Russell City Energy Center
(01-AFC-7C)

Petition for Modification
Amendment No. 6

Submitted by
Russell City Energy Company, LLC
January 2016

Figure 1: RCEC Demineralized Water Treatment System

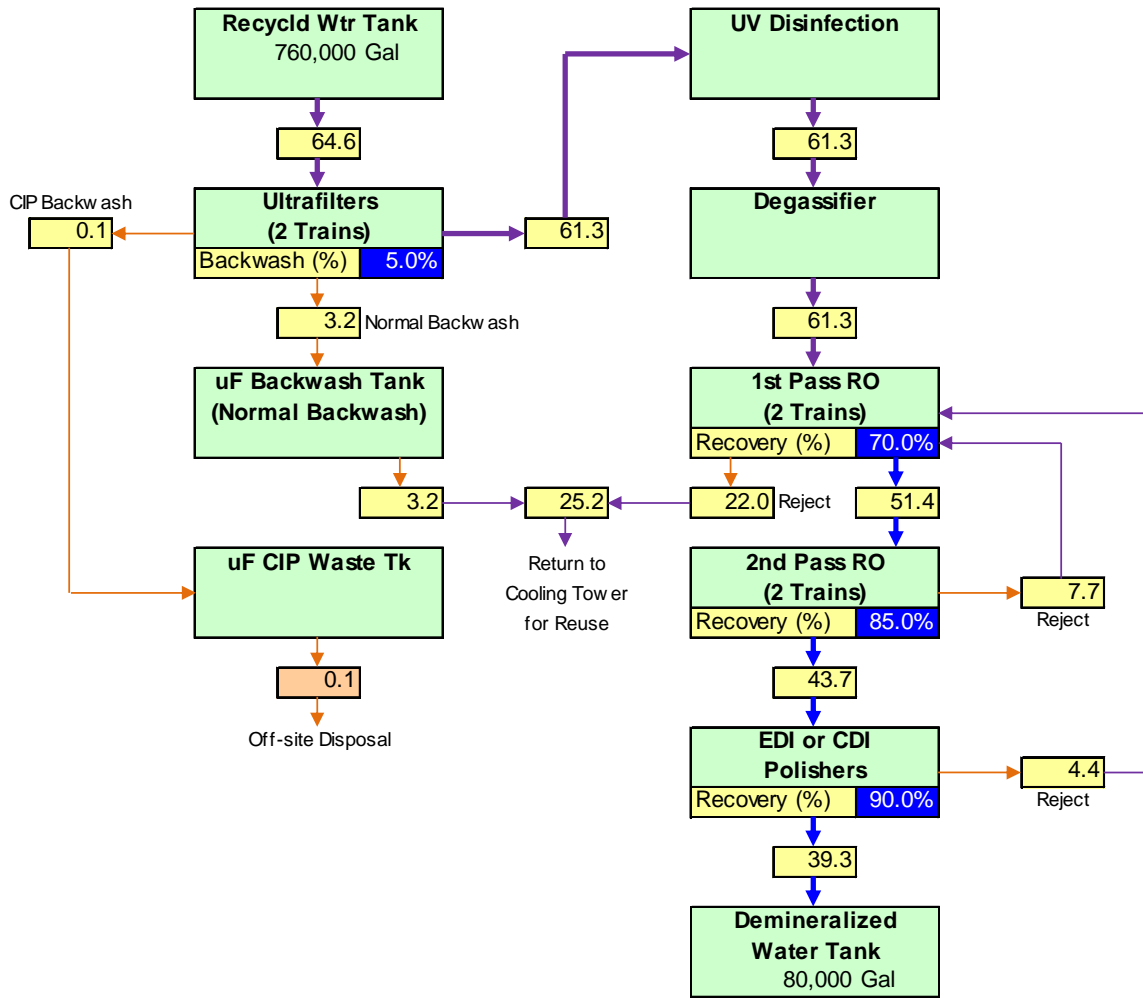
Recycled water will first pass through self-backwashing strainers and then proceed to two ultrafiltration units. Filtered effluent will then pass through a disinfection step utilizing ultraviolet light. Filtered, disinfected water will then proceed through a degassifier for removal of carbon dioxide. Degassifier effluent will feed the first pass RO units. First pass RO permeate will feed the second pass RO units, and second pass RO permeate will feed the electro-deionization (EDI) or continuous de-ionization (CDI) units. EDI or CDI permeate will then be sent to the demineralized water storage tank.

Proposals have been received from two qualified suppliers and are currently being evaluated. Both proposals utilize the same process blocks and similar technology. A basic block diagram of the system appears in Figure 1.
